R. E. GINNA NUCLEAR POWER PLANT

AMENDMENT TO FACILITY OPERATING LICENSE

Amendment No.72  
License No. DPR-18

ATTACHMENT TO LICENSE AMENDMENT NO. 72

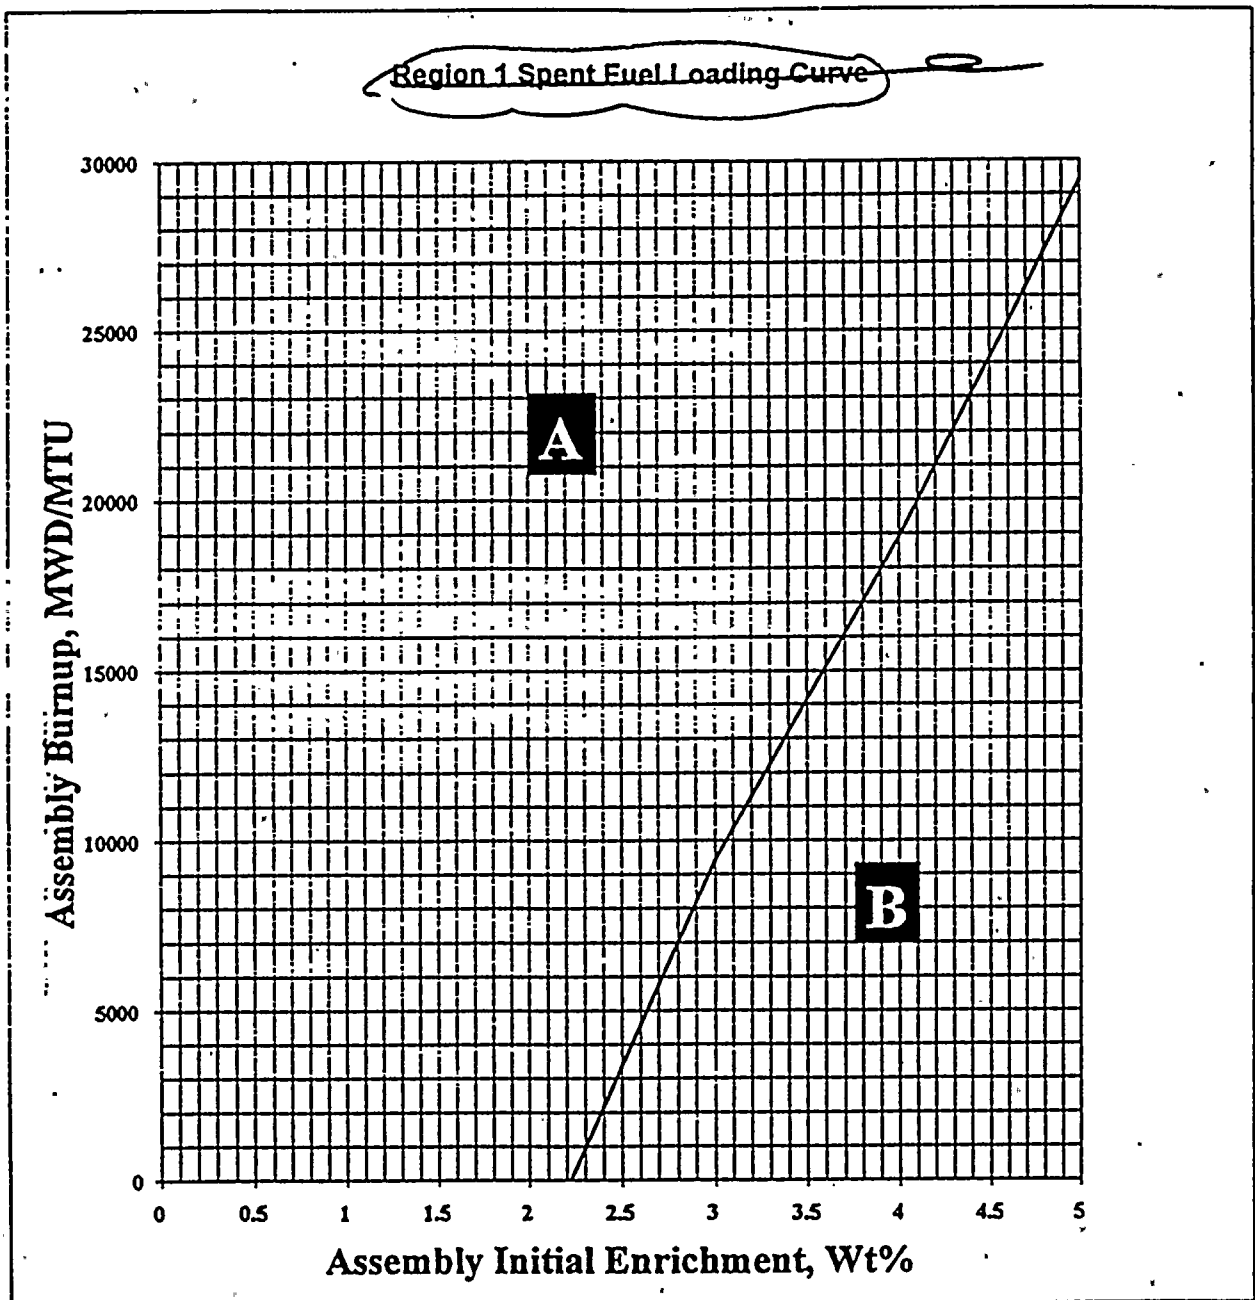
- a. Fuel assemblies in Region 1 shall have a K-infinity of  $\leq 1.458$  and shall have initial enrichment and burnup within the acceptable area of Figure 3.7.13-1; and
- b. Fuel assemblies in Region 2 shall have initial enrichment and burnup within the acceptable area of the Figure 3.7.13-2.

SURVEILLANCE		FREQUENCY
SR 3.7.13.1	Verify by administrative means the K-infinity of the fuel assembly is $\leq 1.458$ and that the initial enrichment and burnup is in accordance with Figure 3.7.13-1.	Prior to storing the fuel assembly in Region 1
SR 3.7.13.2	Verify by administrative means the initial enrichment and burnup of the fuel assembly is in accordance with Figure 3.7.13-2.	Prior to storing the fuel assembly in Region 2

Figure 3.7.13-1  
Fuel Assembly Burnup Limits in Region 1

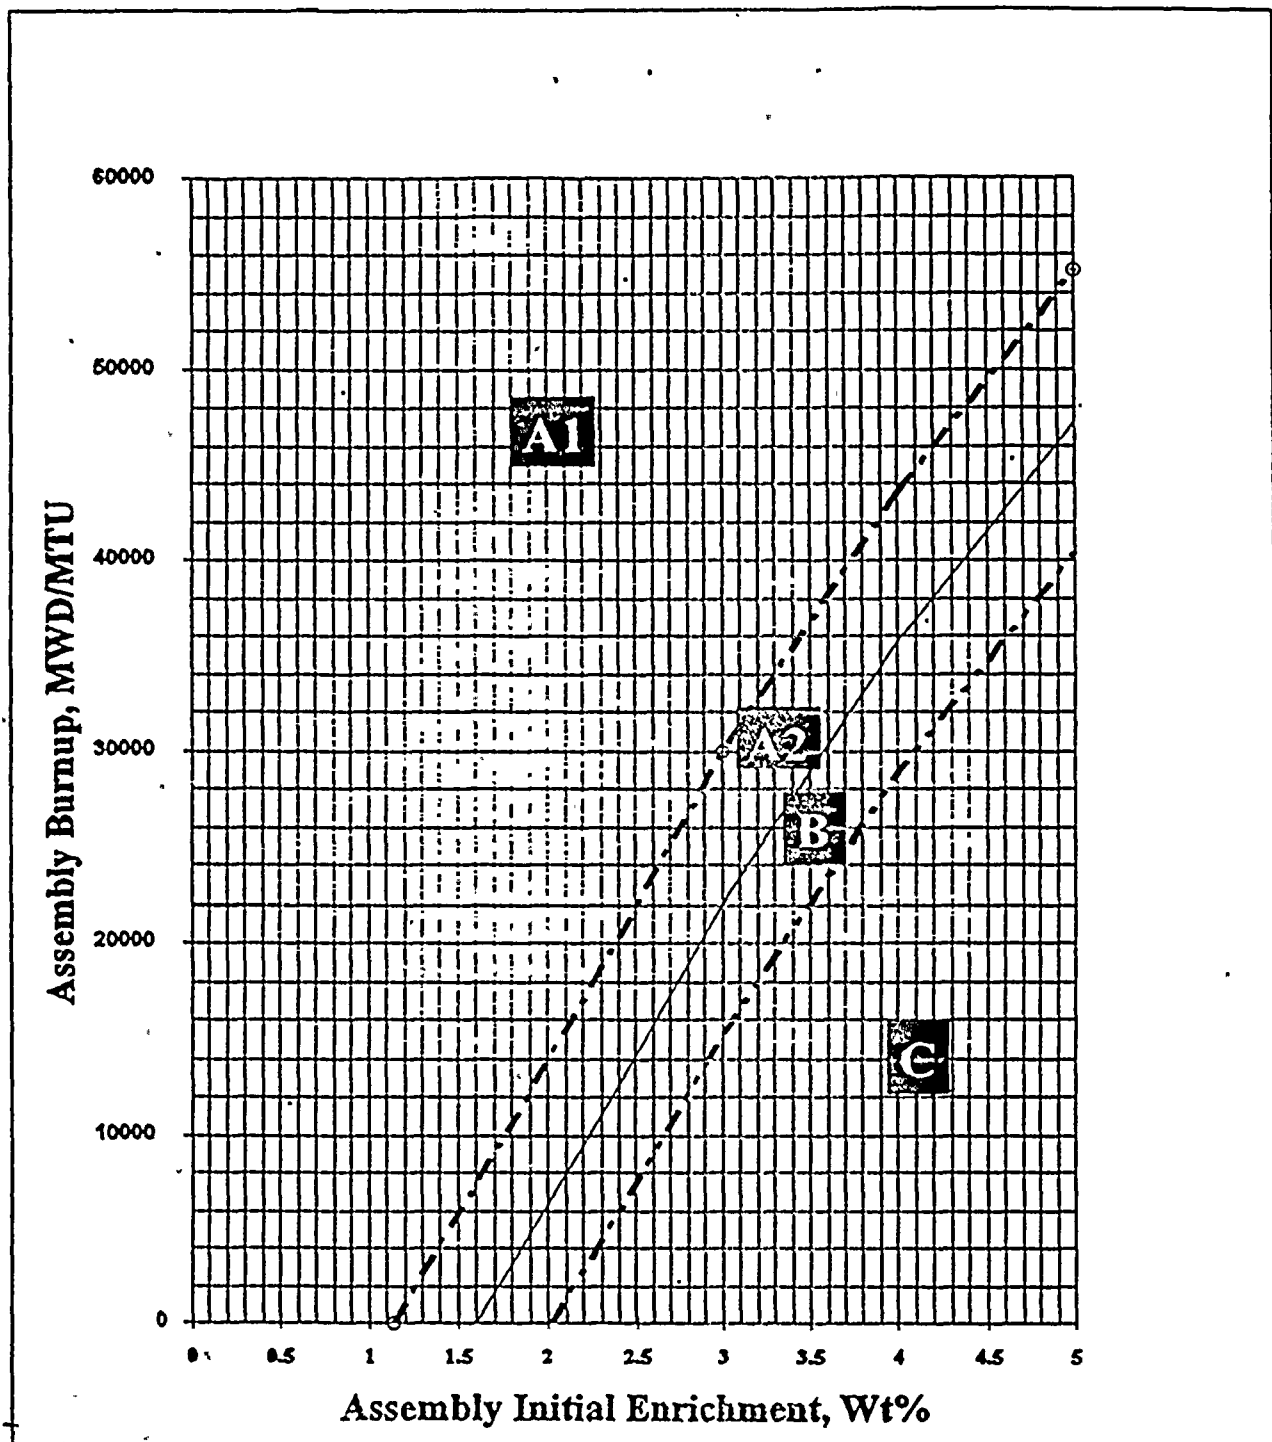
- A - Acceptable burnup domain for storage in any location within Region 1.  
B - Acceptable burnup domain for storage in cells with lead-in funnels only.
